# Structural Checksheet Response

**Permit #:** 12-176776-000-00-CO

**STRUCTURAL CHECKSHEET**

Description of Work: Solar/PV panel ADD ROOFTOP SOLAR ARRAY TO SOUTHERN BUILDING

Company/Project: RNS Consulting LLC / existing roof truss *w/EXIST. LOADS*

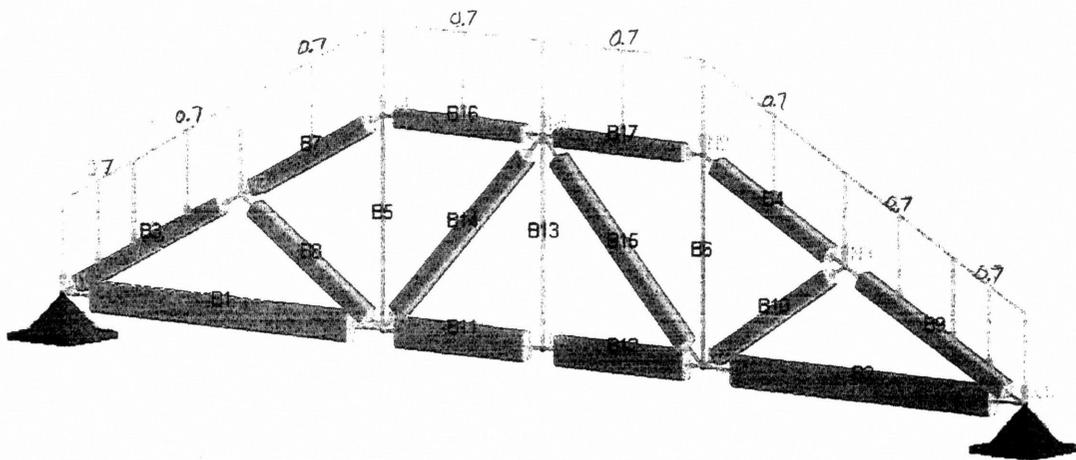
8. *Provide information showing that the truss connections are adequate to support the increased loads, or show that the increased loads are less than 5% of the original design loads.*

Calculations comparing the stress due to the new loads versus the stress due to the existing loads are attached.

EXIST. LOADS (Pg. 2-9)	w/NEW LOADS (Pg. 10-18)	% diff.
Bending :	7.826 K-ft	8.222 K-ft	$\frac{(8.222 - 7.826)}{7.826} (100) = 5.0\%$
Compression :	34.261 K	36.069 K	$\frac{(36.069 - 34.261)}{34.261} (100) = 5.2\%$
Tension :	6.300 K	6.640 K	$\frac{(6.64 - 6.3)}{6.3} (100) = 5.3\%$
Shear :	3.130 K	3.305 K	$\frac{(3.305 - 3.13)}{3.13} (100) = 5.3\%$

5% difference :: ok

### EXAMPLE FORCE DERIVATION ON SINGLE PANEL

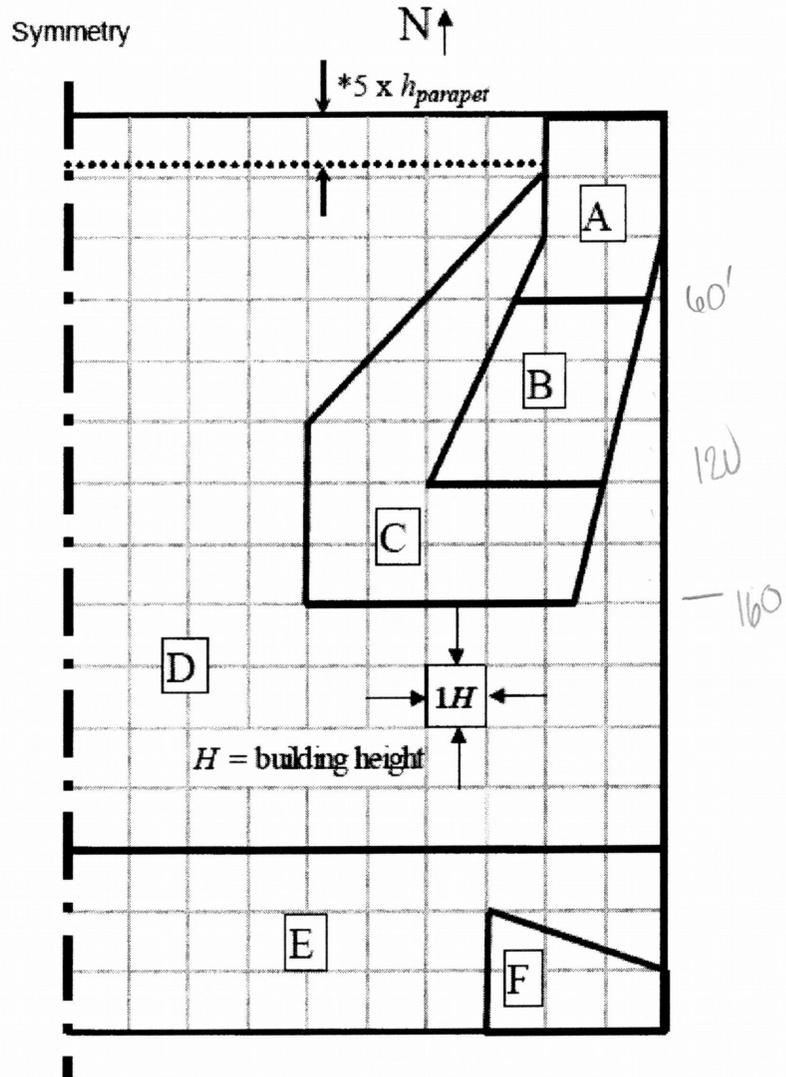
1. "Provide the design that Taylor and Syfan is verifying. It appears that the loads are based on wind tunnel testing. Please provide the wind tunnel tests along with an explanation of how the loads on the panel in this project are determined."

The Wind Tunnel Testing Report may be supplied by SnapNrack. Please find the example procedure for deriving the force to a single panel that follows in addition to an outlined explanation of the results found from applying the Wind Tunnel Testing procedure.

$$W_{REQ'D} = 183\# \times (1 - 0.30)$$

$$= 128\#$$

## LOAD FLOW IN PV PANEL (SERIES 450 INSTALLATION)

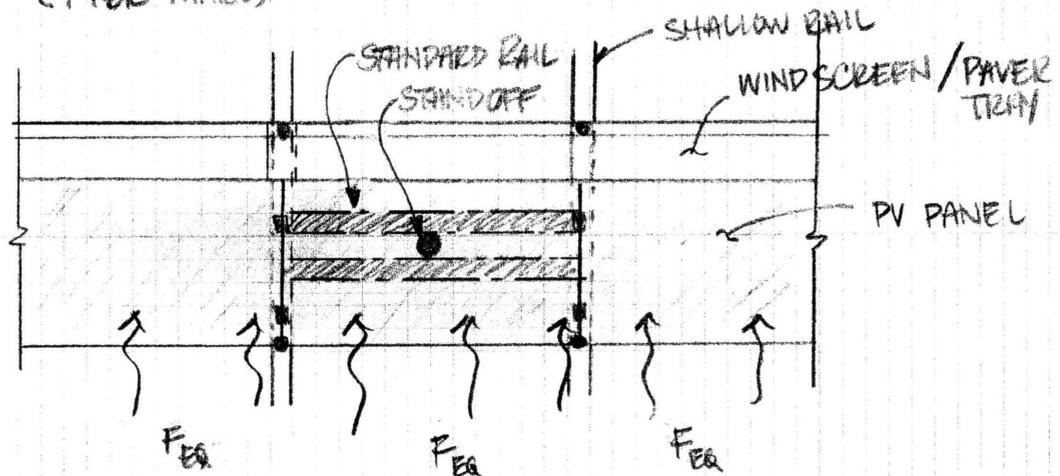
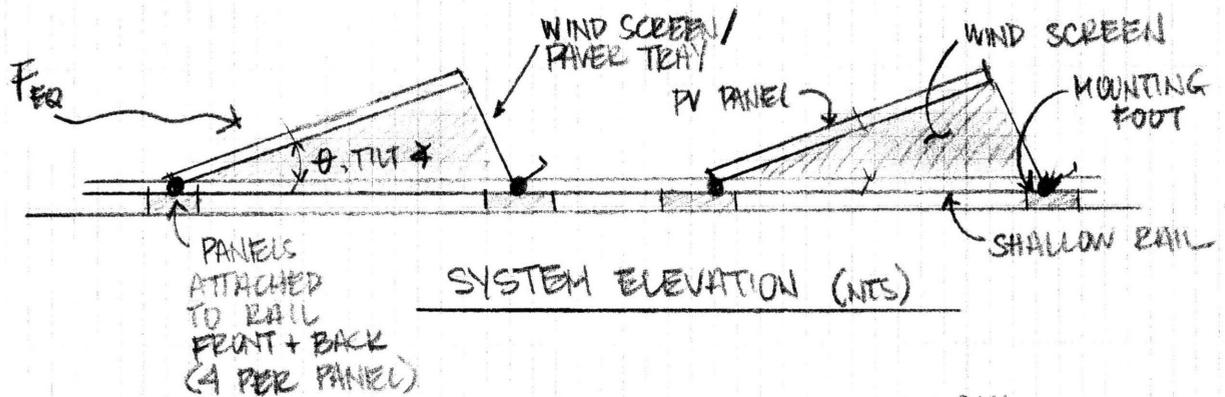
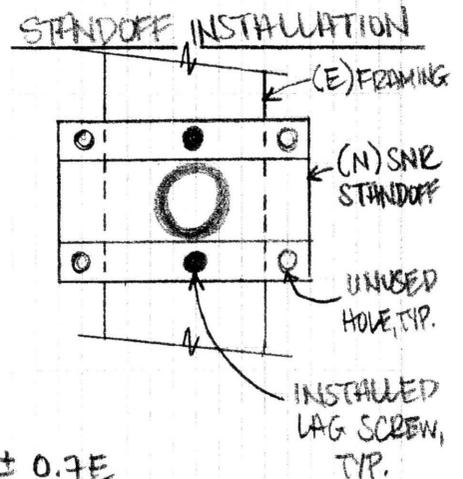
2. "Show how the lateral loads are transferred through the panel arrays to the standoffs. For example, there is only 1 standoff for the lower left corner of the plan. There are no standoffs for the 16 panels at the north building, near the center. Provide a design for the standoffs showing their capacity to resist combined tension and bending loads."

Please find the included explanation of load flow through the PV panel system for transfer of force to the standoffs in a subarray. The subarray referenced in the center of the installation is positively connected to a single standoff; however, we suggest adding another standoff for balanced lateral force resistance to the panel indicated in the pages that follow (specifically, page 8/11.) The original anchorage calculation, including design of the standoff connection, can be found on page 1.08 of the original "Structural Calculations" dated August 3, 2012. Page 11 of the calculations contained herewith also identify the proper orientation for the installed standoffs, each installed with (2) lag screws of size and type as indicated. Please find the additional calculation for both uplift (wind) and lateral (seismic) forces on a single standoff as requested.

PANELS ARE INSTALLED WITH RIGID PAVER TRAYS ALONG BACK OF PV PANEL, RIGID WIND SCREENS AT EDGES, AND ARE INTER-CONNECTED WITH NEIGHBORING PANELS TO FORM A RIGID UNIT IN THE EAST-WEST DIRECTION. PANEL ROWS ARE ALSO INSTALLED ON "SHALLOW RAILS" THAT RUN CONTINUOUSLY ALONG THE NORTH-SOUTH LENGTH OF THE SUB-ARRAY, RIGIDLY LINKING THE ENTIRE SUBARRAY + PROHIBITING INDEPENDENT PANEL BEHAVIOR. AT A STANDOFF LOCATION, (2) STANDARD RAILS SPAN FROM THE NEIGHBORING SHALLOW RAILS TO EFFECTIVELY CAPTURE AND RESIST THE LATERAL FORCES OF THE TRIBUTARY SUBARRAY.

$$\frac{D}{C} = \frac{239.6\#}{240} = 0.998$$

$$\frac{D}{C} = \frac{116\#}{360\# \times 2} = 0.161$$

$\therefore$  (2) 1/4" LAG SCREENS w/2" MIN. EMBED OK FOR ANCHORAGE
